SG2A Indication Totals - 4/12/2016 11:58 AM

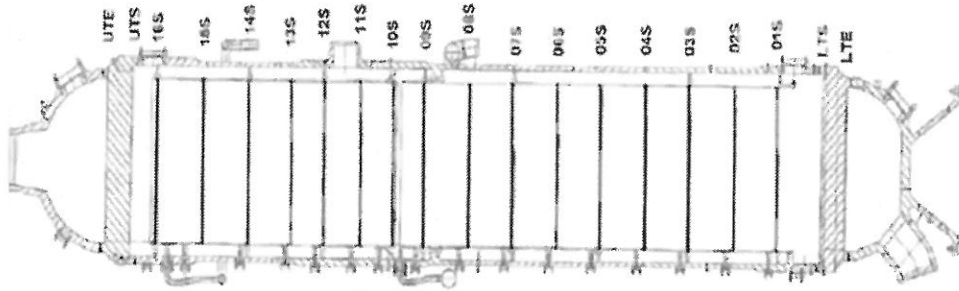
5. *For each area examined (e.g., tube supports, dent/dings, sleeves), provide a summary of the number of indications identified to-date for each degradation mode (e.g., number of circumferential primary water stress corrosion cracking indications at the expansion transition). For the most significant indications in each area, provide an estimate of the severity of the indication (e.g., provide the*

voltage, depth, and length of the indication). In particular, address whether tube integrity (structural and accident induced leakage integrity) was maintained during the previous operating cycle. In addition, discuss whether any location exhibited a degradation mode that had not previously been observed at this location at this unit (e.g., observed circumferential primary water stress corrosion cracking at the expansion transition for the first time at this unit).

Based on current inspection results, all flaws detected meet condition monitoring criteria for structural and leakage integrity and have done so for the entirety of the previous cycle.

The only degradation detected to date is wear at TSP intersections. This was expected and addressed in the Degradation Assessment. No unexpected modes of degradation have been identified.

UTE-UTR	ADI	BLG	DDI	DNT	DSI	DTI	IDC	INC	LPI	NQI	OBS	FLP	PTB	PTR	PTU	P'VN	SVI	TWD	VOL	WAR	W/PX	W/SI	
UTR																							
UTR-UTS																							
UTS																							
UTS-16S																							
16S																			132				
16S-15S																			1				
15S					7														90				
15S-14S																							
14S																			72				
14S-13S																							
13S																			6				
13S-12S																							
12S																							
12S-11S																							
11S																							
11S-10S																							
10S																							
10S-09S																							
09S																							
09S-08S																			3				
08S																							
08S-07S																							
07S																							
07S-06S																							
06S																							
06S-05S																							
05S																							
05S-04S																							
04S

04S-03S																							
03S																							
03S-02S																							
02S	1																						
02S-01S																							
01S	1																						
01S-LTS																							
LTS																							
LTS-LTR																							
LTR																							
LTR-LTE																							
Total	2	0	0	7	7	0	0	0	0	0	0	0	0	0	0	0	0	351	0	0	0	0	0
